INSERVICE INSPECTION

ISO. NO: MCFI INI 62
DUKE PIPING CLASS: ASME SECTION III CL. A
SYSTEM SYMBOL: NI - SAFETY INJECTION
PIPING SPEC: NI 17 PS. 1501.1
DRAWING NO.: MC 1414-09.22-00 EL. 738'-3"
PROJECT: MCGUIRE

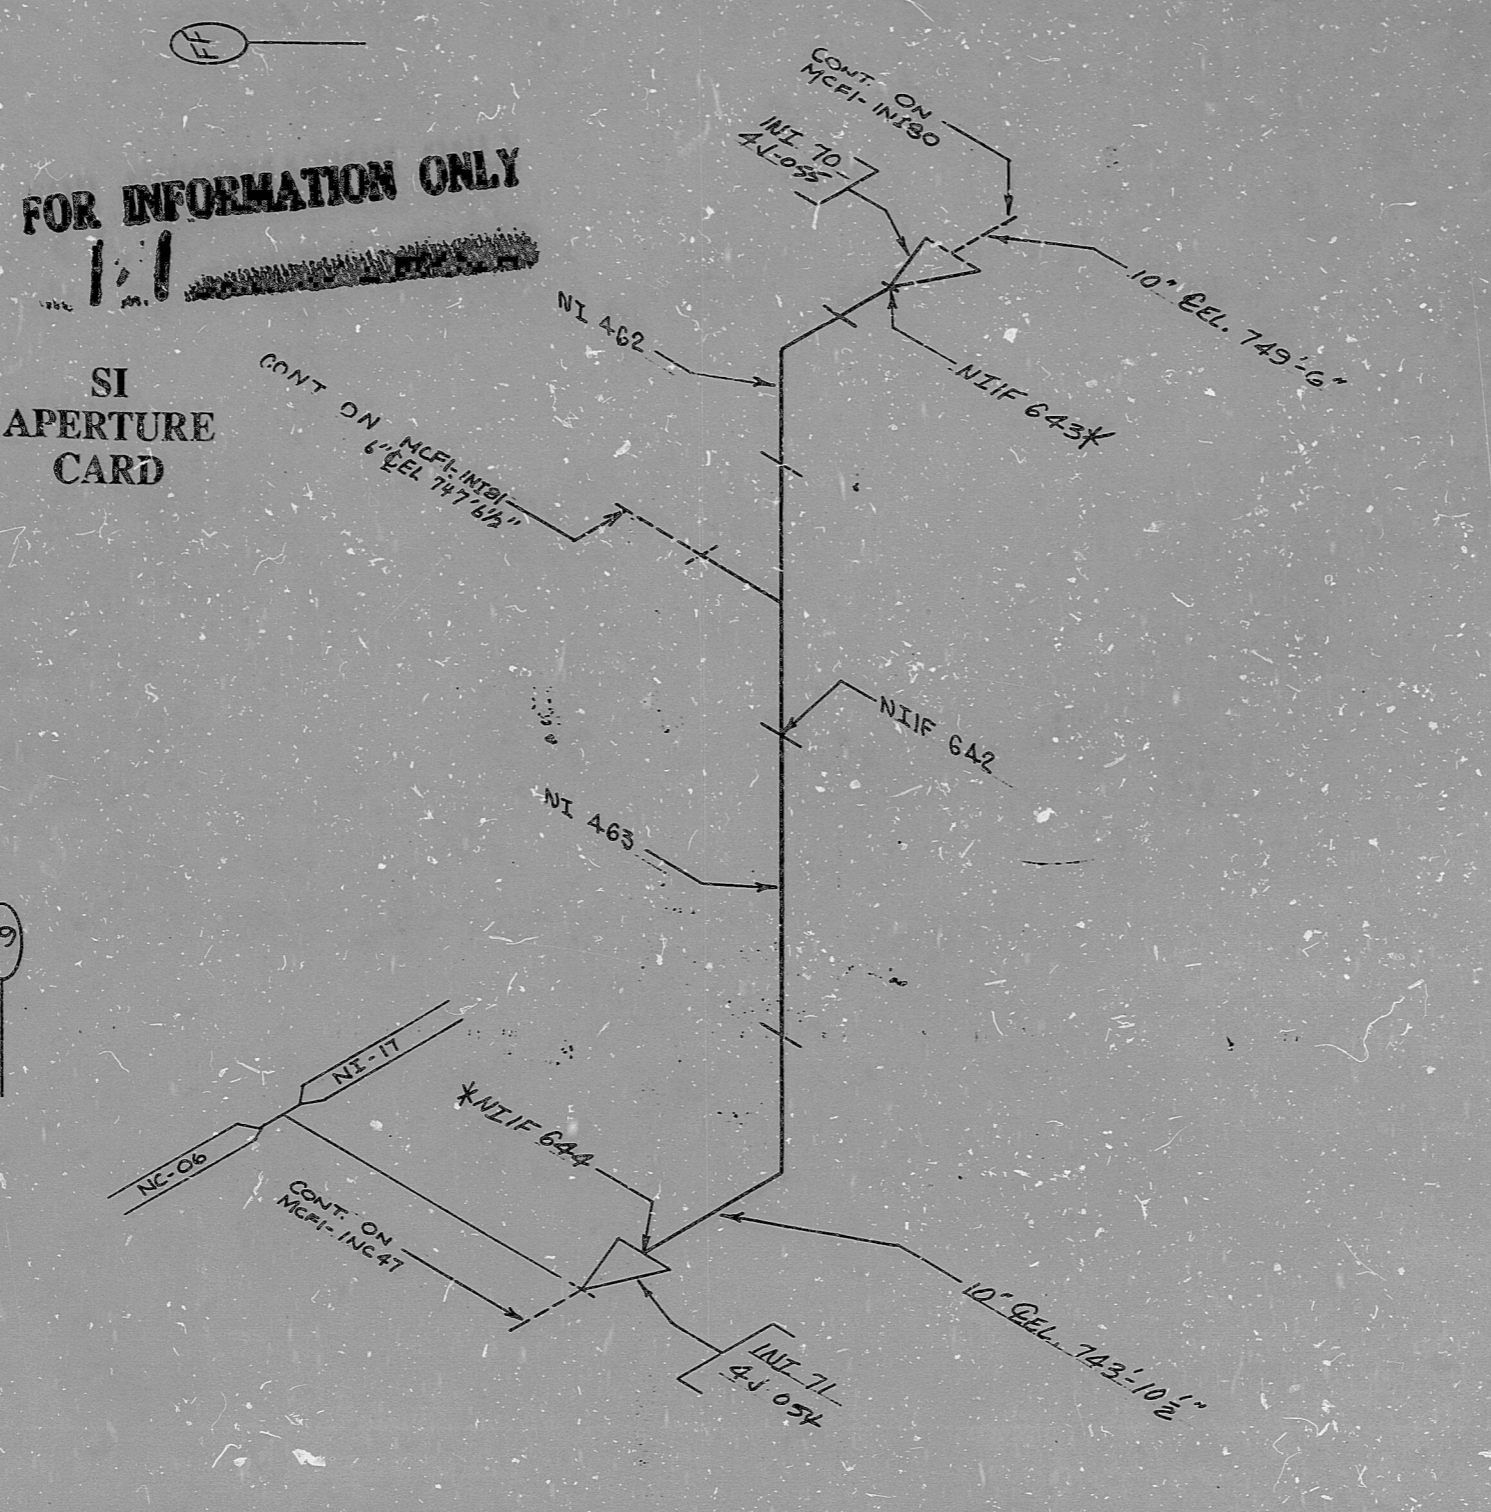
NO.	REVISION	DATE	CHG.	BY	CHK.	APP.	DATE
4	CHANGE ITEM # OF VALVES NI 71 TO (N)650 AND NI 70 TO (R) 055 ADD NOTE K TO WELDS ASIF 644 AND NIIF 643 CUSTOMER - 1783	6/17/71	MM	MM	MM	MM	6/17/71
3	CHANGED CONTINUATIONS	7/20/71	MM	MM	MM	MM	7/20/71
2	ADDED CONTINUATIONS	12/1/71	MM	MM	MM	MM	12/1/71
1	REVISED TO ADD CONTINUATIONS	8/23/71	MM	MM	MM	MM	8/23/71
0	RELEASE FOR CONSTRUCTION	7/20/71	MM	MM	MM	MM	7/20/71
	REVISION QA CONDITION I
